Statutory Comments (07/10/2025)

Your ref: LCC/2023/0030
Our ref: LCC.D2.2023.0030
Date: 7th October 2025

Application no: **LCC/2023/0030**

Address: **Land off Bourbles Lane, Preesall**

Drawing 2 - Max Artic Vehicle Swept Path - Vehicle within Highway Extents (conflict at centre of Carriageway)

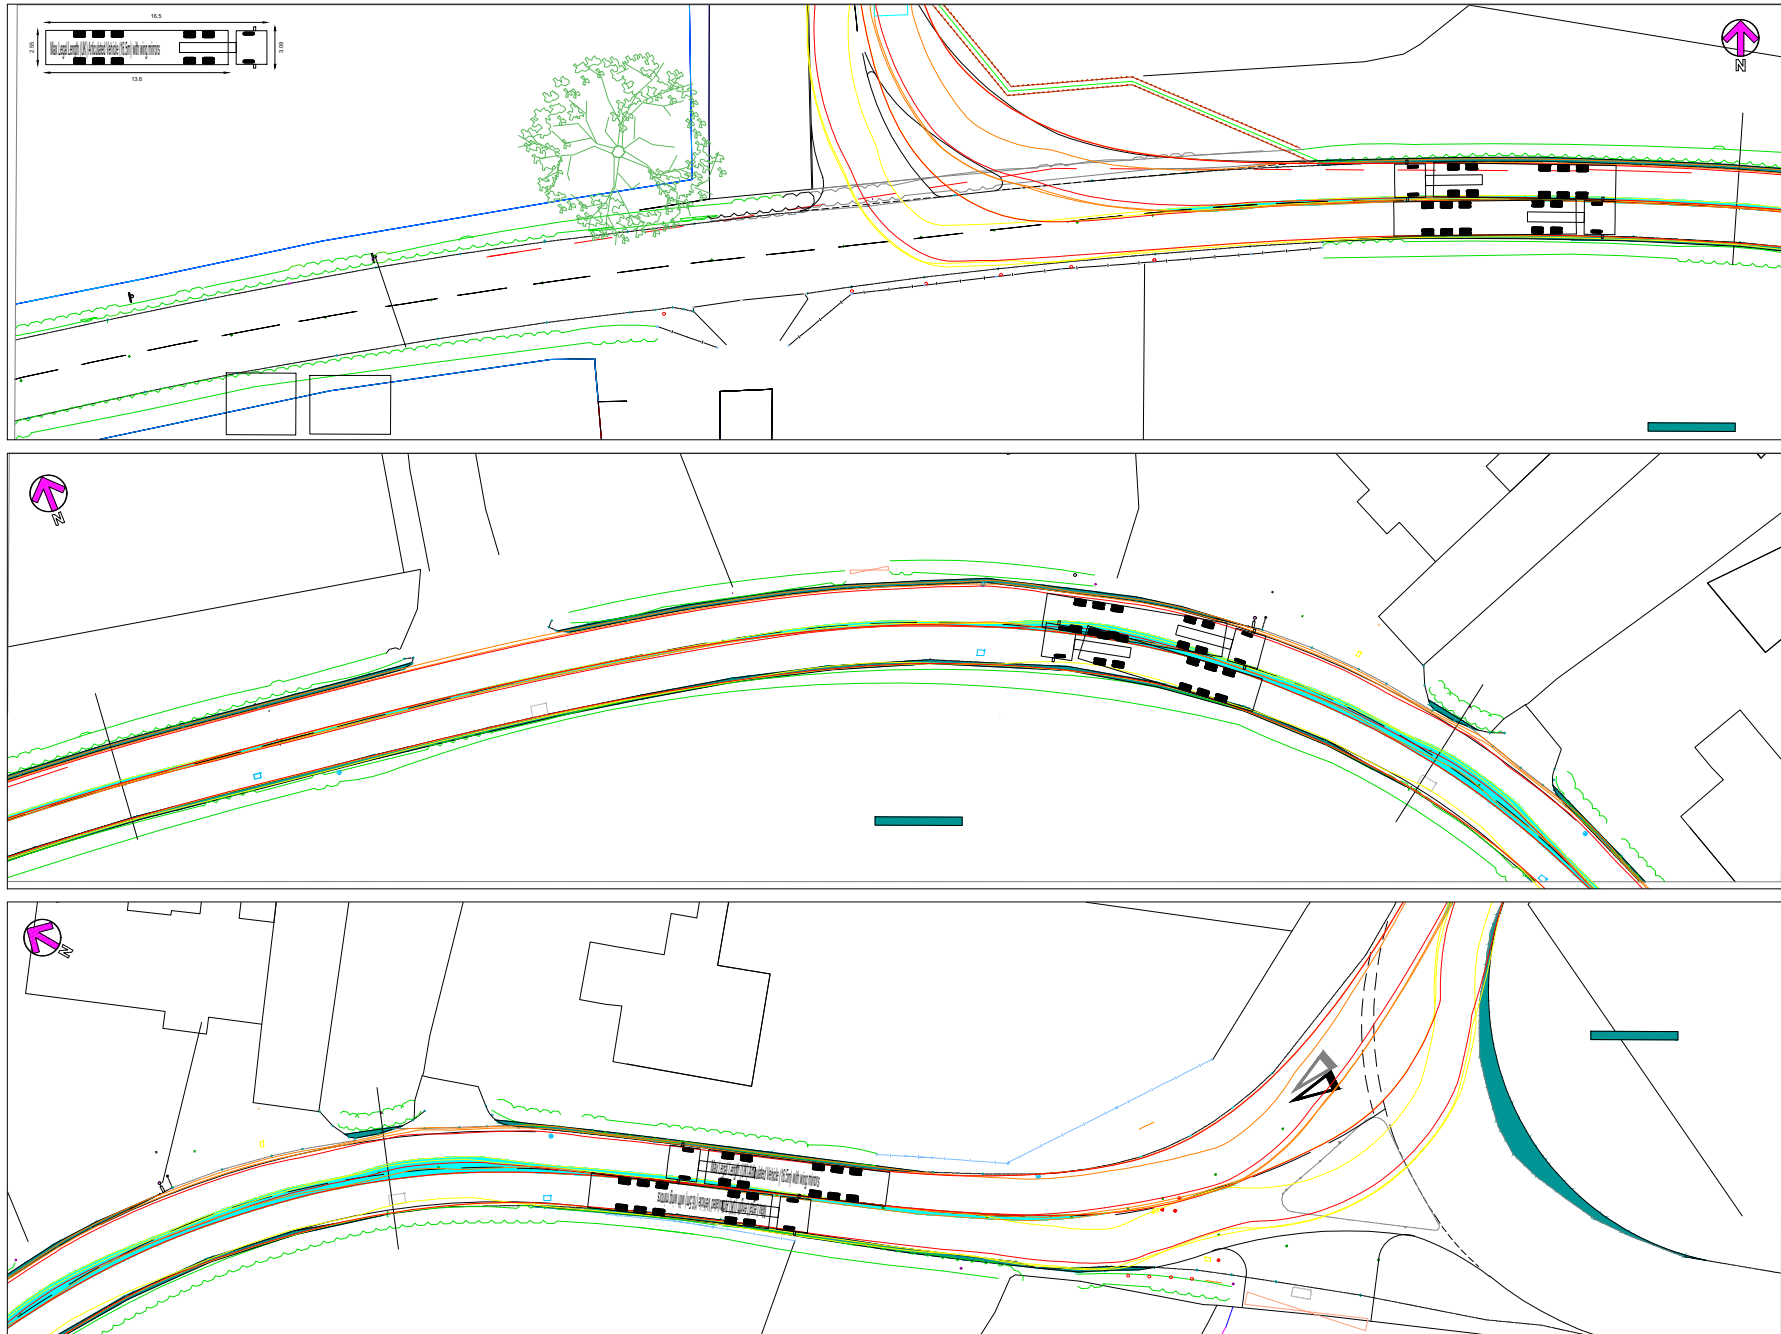
Area of Conflict

Drawing 3 - Max Artic Vehicle Swept Path - No conflict at centre of Carriageway (Vehicle beyond Highway extent)

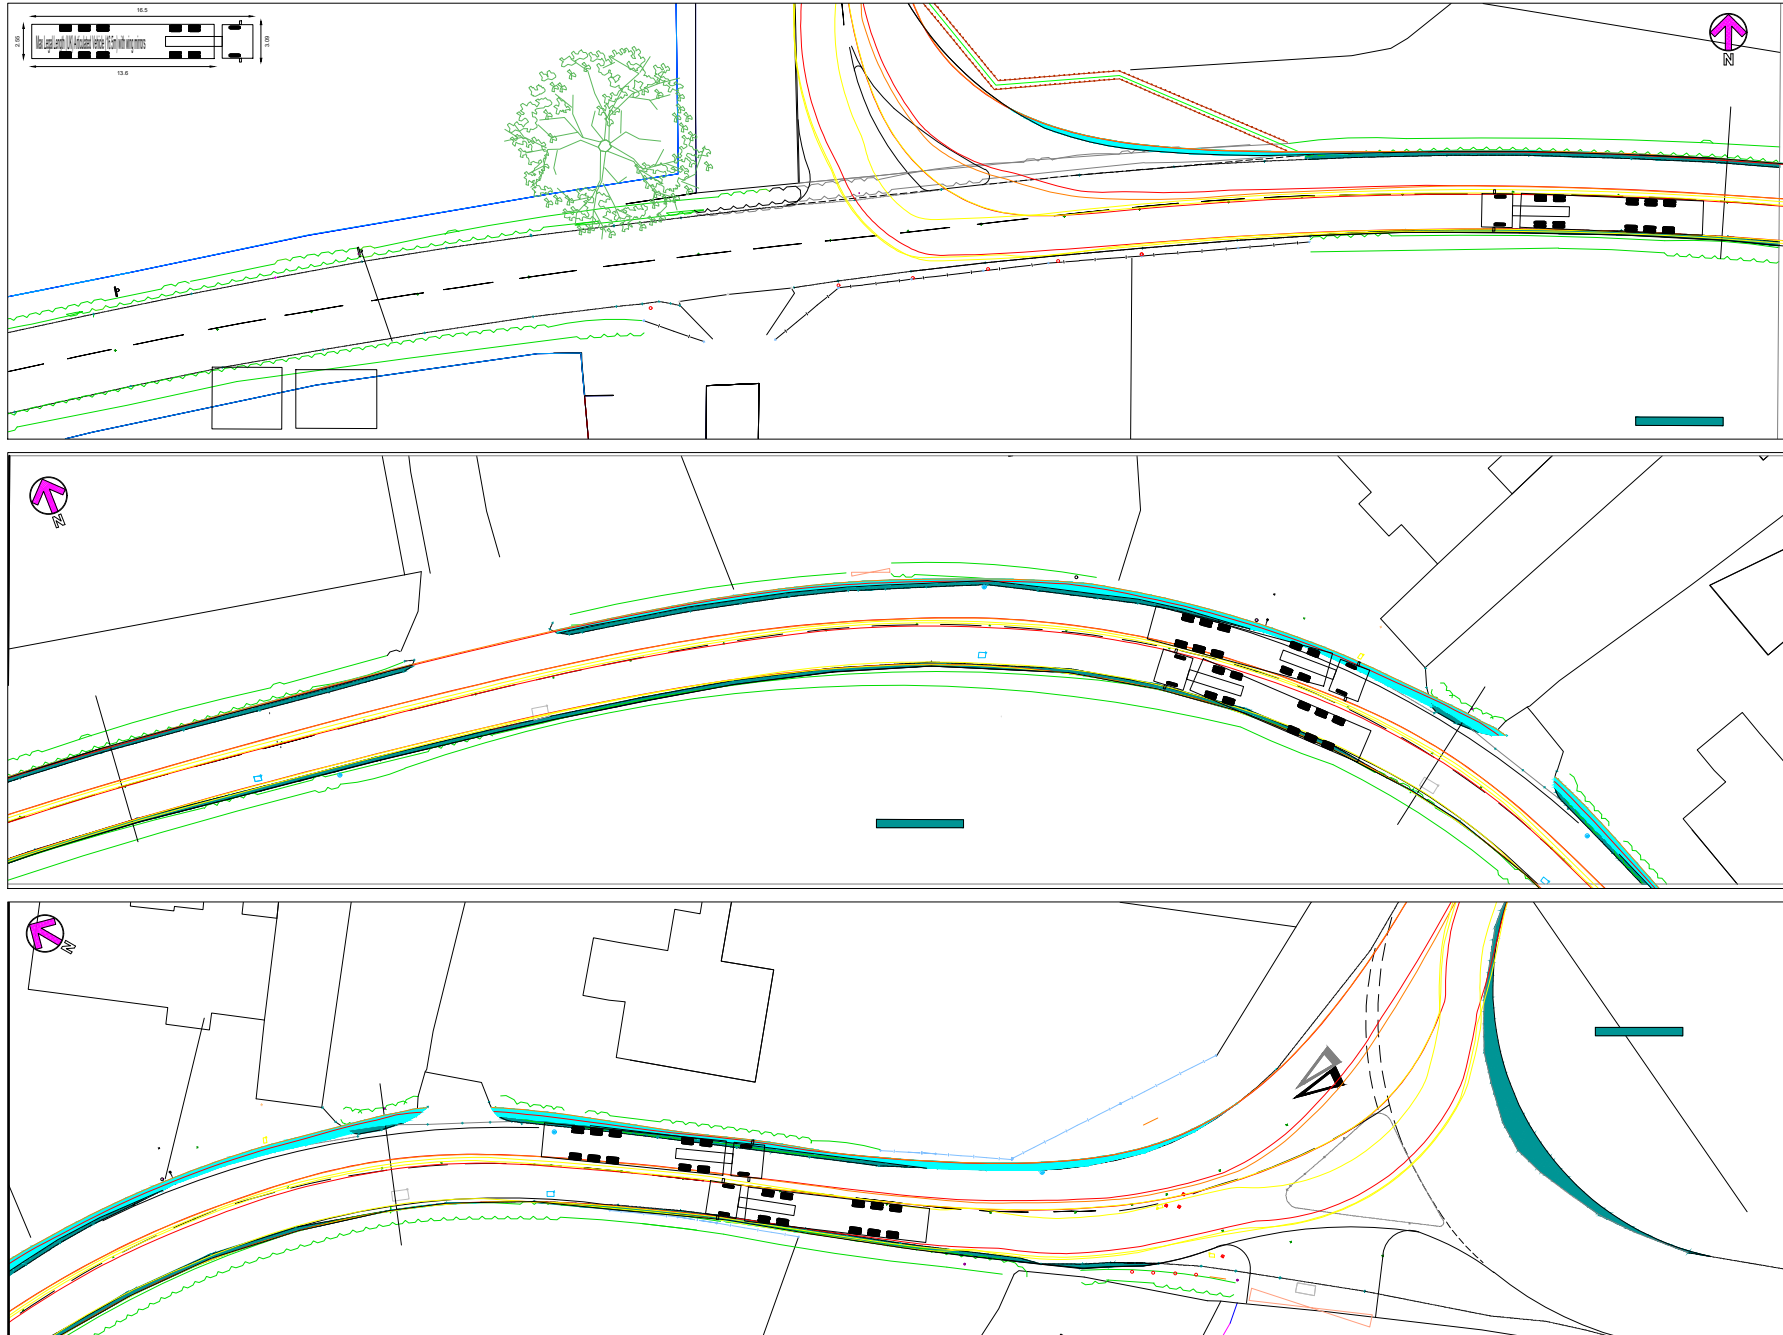
Area exceeding Highway
